the
**Large
 Hadron
 Collider**
 project

LHC-LJ-EC-0003

Engineering Change Order – Class I

Integration of Tertiary Collimators, Beam-Beam Rate Monitors and Space Reservation for a Calorimeter in the Experimental LSS's

Figure 1 Horizontal (left) and vertical (right) phase advance from D2 to the superconducting triplet, shown as a function of the beta value in the interaction point [2].

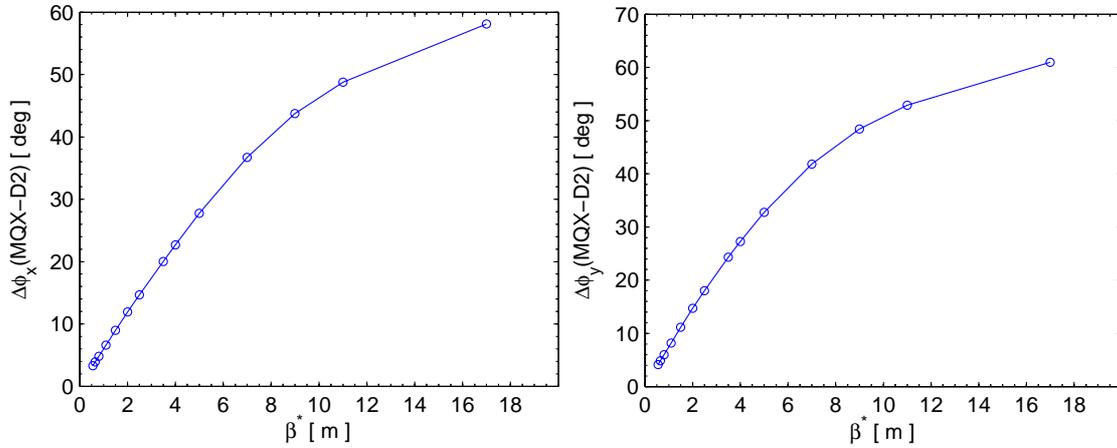
Based on various studies a location close to the D2 magnets was identified as the optimal position for TCT's. From Figure 1 it is seen that the phase advance error from D2 to the super-conducting triplet is acceptable for small β^* . The two beams are well

Figure 2 Drawing of the TCS tank (left) and possible Cu/W jaw layout (right) for the TCT collimators at the D2 location [3].

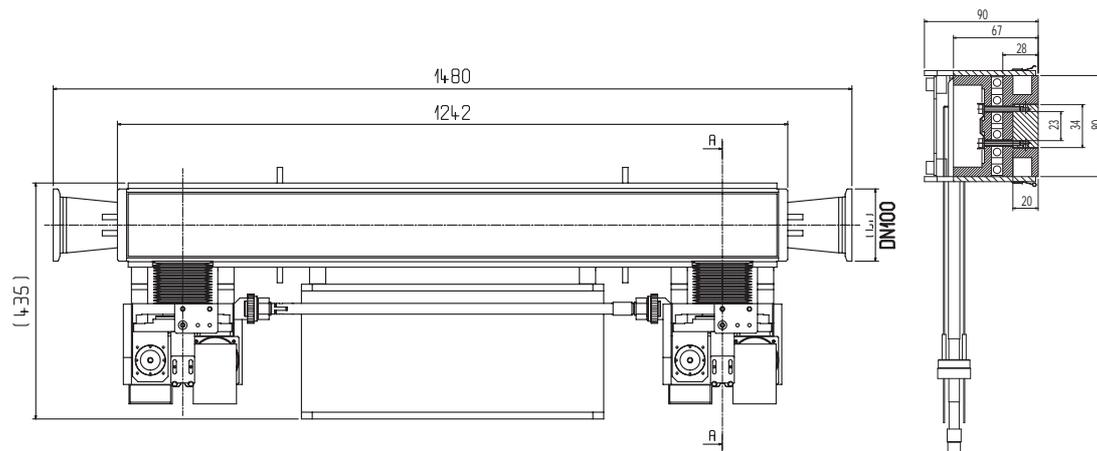
The design of the TCT collimators at the D2 location is derived from the TCS (secondary collimator) design [3] as shown in Figure 2. The outer dimensions of the tank are identical to the TCS design and are summarize shortly:

The main difference between the TCS and the TCT designs concerns the jaw assembly. For the TCT's it is foreseen to use a copper jaw mounted on a cooling plate, possibly with a tungsten inlet. A possible scheme for a Cu/W jaw is illustrated in Figure 2. Once the new layout is approved, detailed showering studies will be performed and the material in the active part of the TCT jaw (copper or tungsten) will be decided based on the results.

Figure 3: Beam-beam rate monitor (BRAN), XZDC and TCT integration in IR2 R (IR2 L symmetrical; supports not detailed).

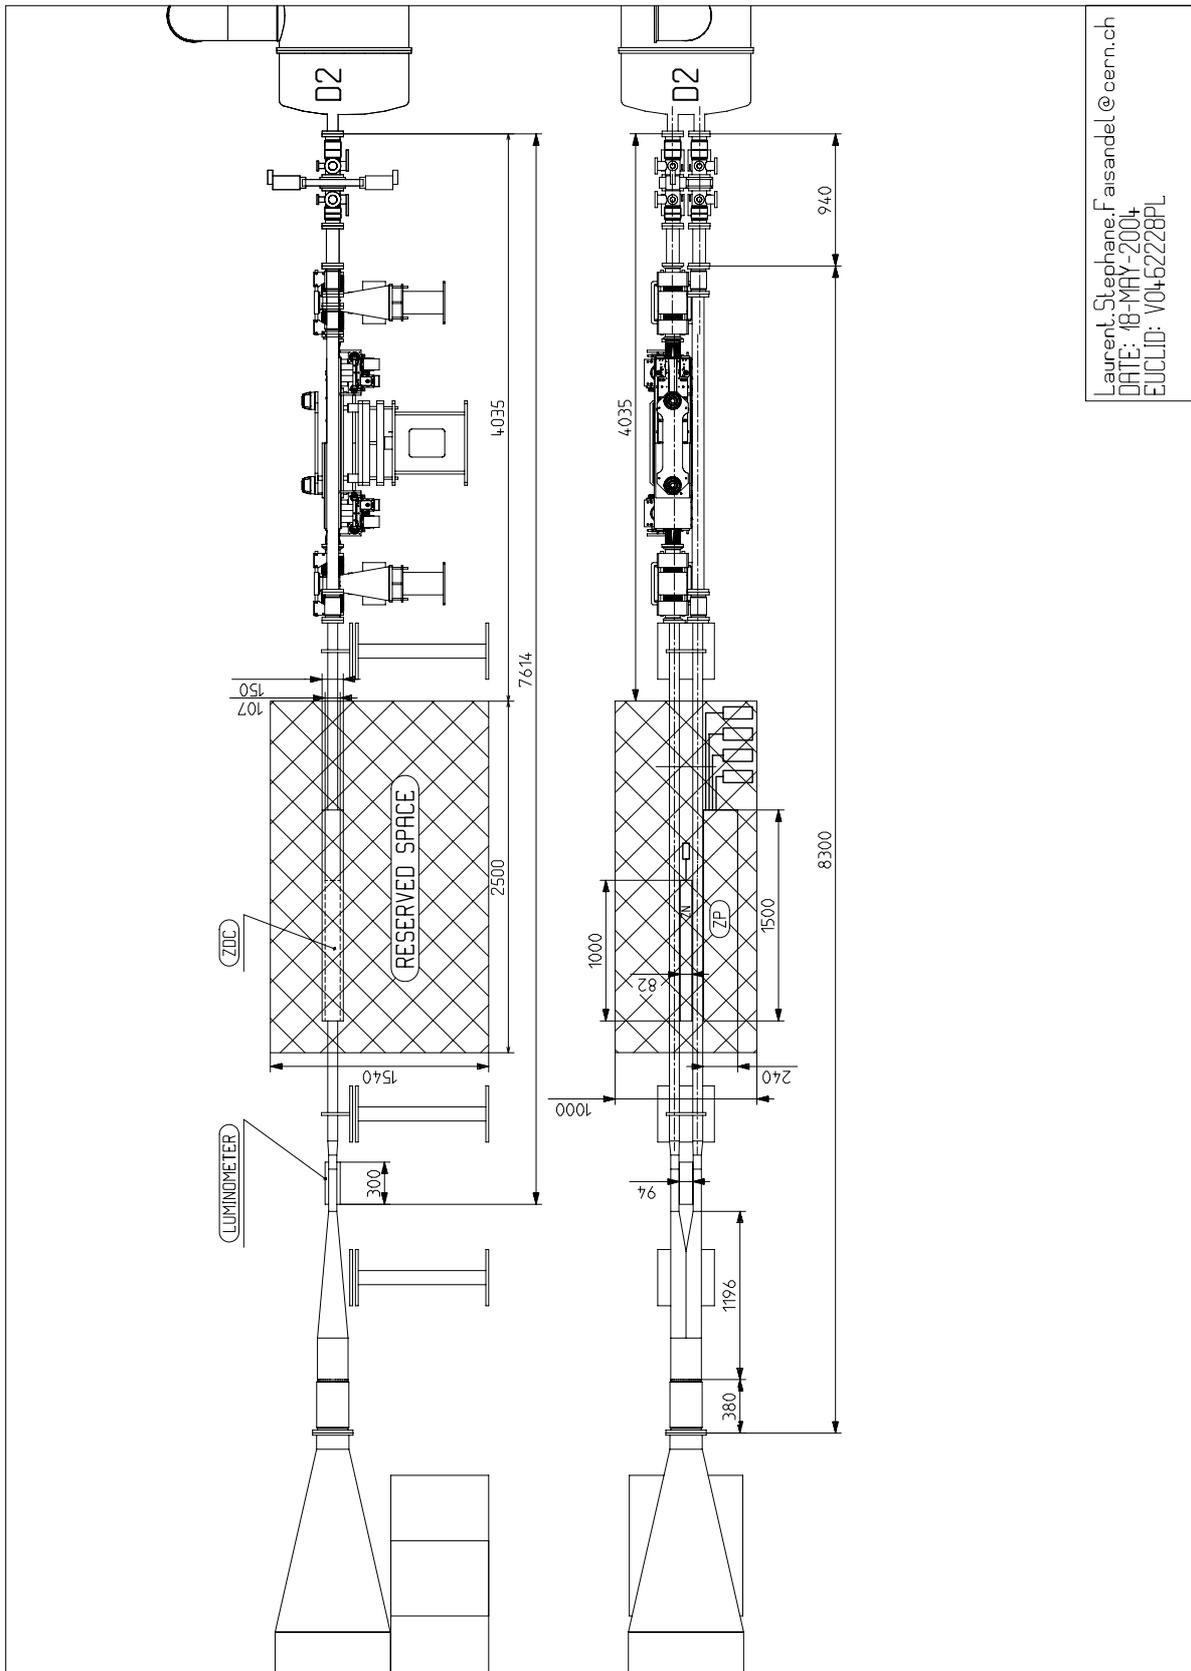
In collaboration with AT-VAC, (C. Rathjen), a solution has been found by placing the monitors in between the two tubes of the recombination vacuum chamber, where a larger distance between the two beam pipes can be obtained. It is agreed with AT-VAC to have a region of at least 0.3 m where the beam pipes will leave a clear distance of 100 mm (minus 3x2 mm for all manufacturing and alignment tolerances and the bake-out system), as seen in the case of IR2 right on Figure 3, (courtesy of C. Rathjen).

The recombination chamber continues after the two skewed cones (similar to TAN chamber geometry) into two straight tubes (see Figure 3). The length of these tubes is 400 mm for IR2 and 1000 mm for IR 8. These two tubes represent the internal aperture bottleneck of the chamber for the converging beams. A clearance of 3 mm on each side to the 94 mm BRAN is at the moment foreseen. It can be increased to 4.5 mm for a tubes of 1.5 mm wall thickness. The optimal value will be a compromise between bakeout requirements and fabrication tolerances.

Figure 4: The picture shows the interference between the DSL link and the BPTX support in case the BPTX is placed within the first 1850 mm from Q4.

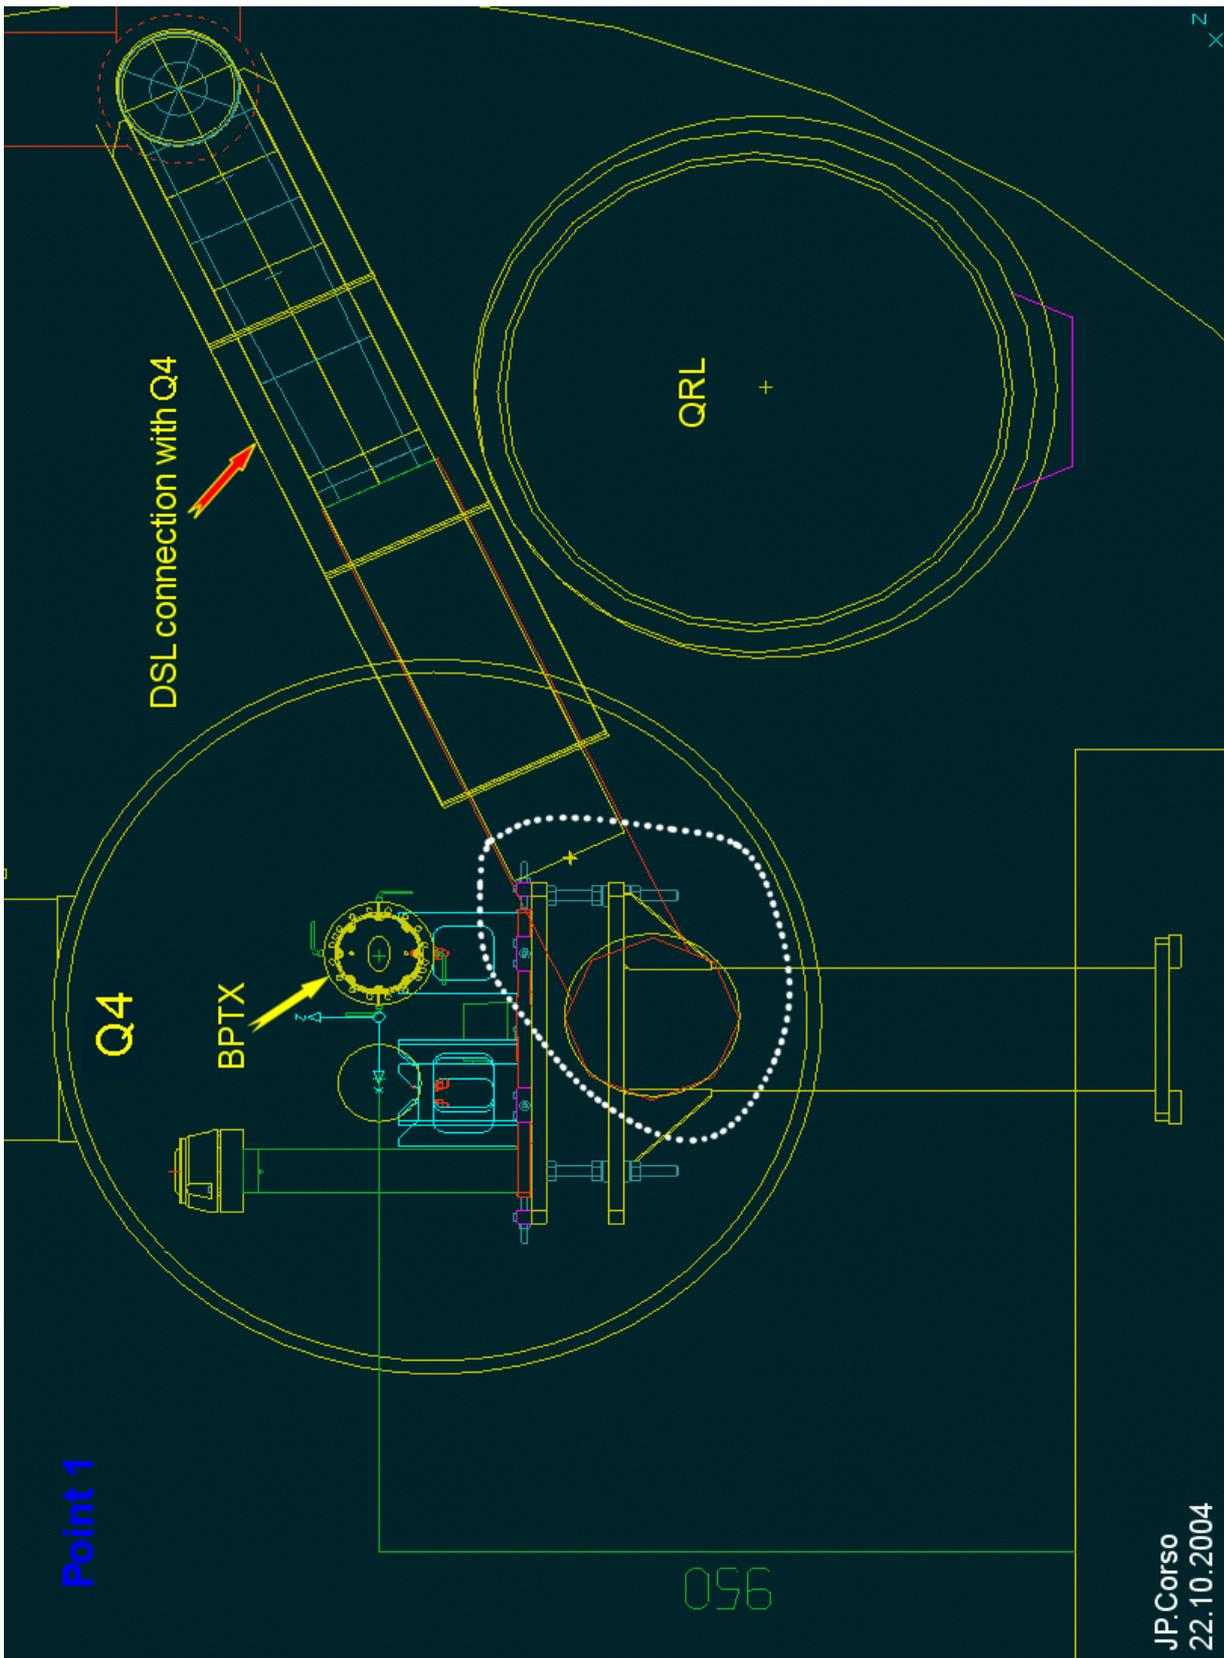
The BPTX positions are changed in all experimental insertions (see Section 4). The new positions can be found in Table 4. The BPTX are now located direct to the sector valve assembly at the Q4's. The length of the BPTX is 285 mm instead of the formerly quoted 500 mm in the LHC functional layout data base. The BPTX positions at Point 1 and 5 avoid interferences with the Q4 DSL link feeding according to the actual link design. If the DSL link design will change in the future, the BPTX supports will probably have to be redesigned accordingly (see Figure 4) or the BPTX has to move further away from Q4. It should be noticed that according to the actual space reservation, the BSRT and BWS supports may also interfere with the DSL link at Point 5. However these devices are not in the baseline yet and therefore eventual integration problems will be addressed in the future once the decision to install them is taken.

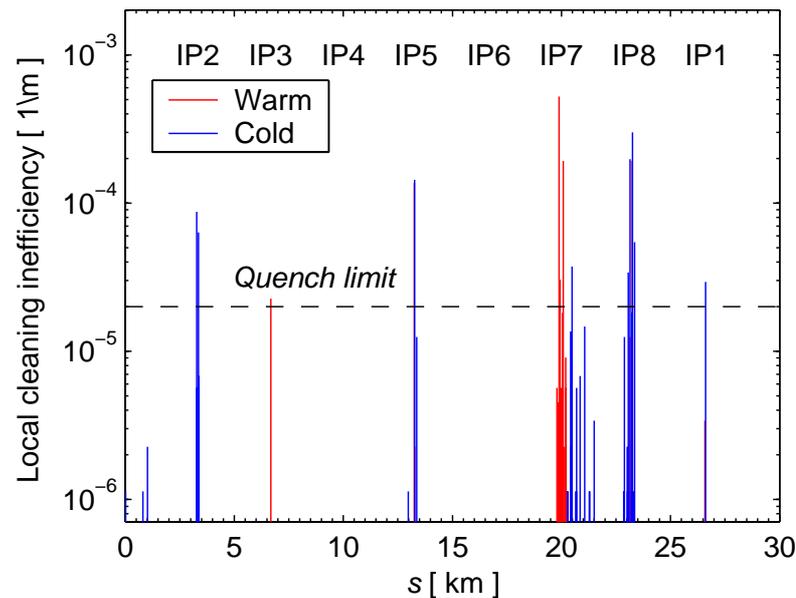
1. Normal operation: The triplets are directly hit by the tertiary beam halo coming from the cleaning insertions. The triplets potentially absorb tertiary beam halo from 8.4σ to 30σ . As a result the triplet can quench or halo-generated background in the experiments can be generated. Figure 5 shows an example calculation of local losses around the LHC ring [5]. A 7 TeV beam halo impacts on the betatron collimators in IR7. A small fraction (tertiary beam halo) escapes and is lost at various aperture limitations in the ring. It is seen that indeed loss spikes occur at the super-conducting triplets in the experimental areas. The predicted losses are above the design operating conditions for the LHC (survival of a transient drop in beam lifetime to 0.2 h with nominal intensity). Tertiary collimators are required to protect the super-conducting triplets against the predicted beam loss.
